# Alice TPC Review

### **The ALICE Review of TPC Distortions**

17-November-2016

# Wire ledges

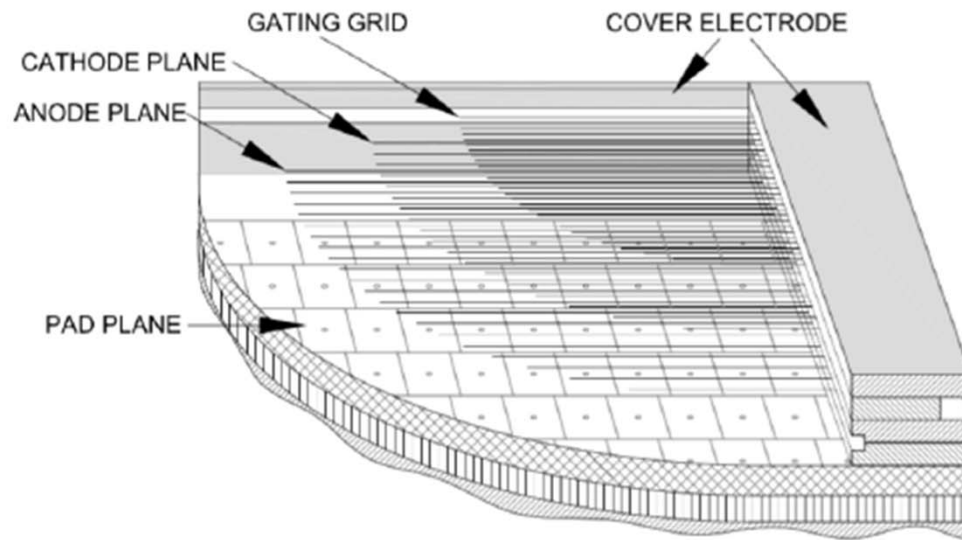
- The anode wires are terminated in a solder ball on one side of the chamber. However, the other end of the wires was simply cut off with a razor blade at the outside wall of the chamber. It is the “cut wire” side of the chamber that generates ions. Normally these exposed wires are covered in epoxy to prevent gas amplification near the exposed tips; however a failure to cover all of the wire tips could lead to ion formation in the gap between the chambers. The essential elements of this idea were proposed by several members of the collaboration and it is another leading candidate to explain the source of the ions.
-

The chamber drawings show a clear difference between left (cathode solders) and right (anode solders) sides. Also, a crucial detail seems to be missing, i.e. the copper electrode on top of the “cover”. As this is capital for understanding the asymmetry in the distortions, it should be clarified.

The exposed-anode-wire model -can easily explain the left-right asymmetry. (One end of the anode wire terminates in a solder ball while the other end terminates in a sharp point; and the point may be exposed to the TPC gas

# Central Electrode

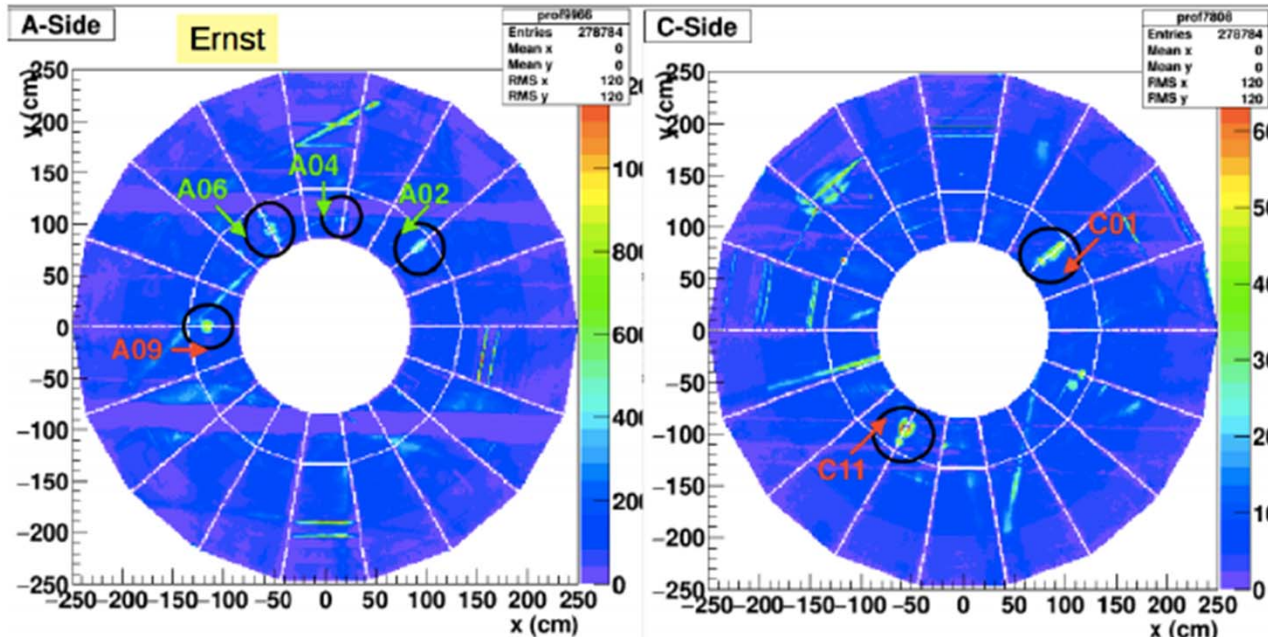
- Distortion hot spots occur always at the same side of the ROC (C-Side is mirrored)
- Individual chambers could be associated to a specific batch during chamber production
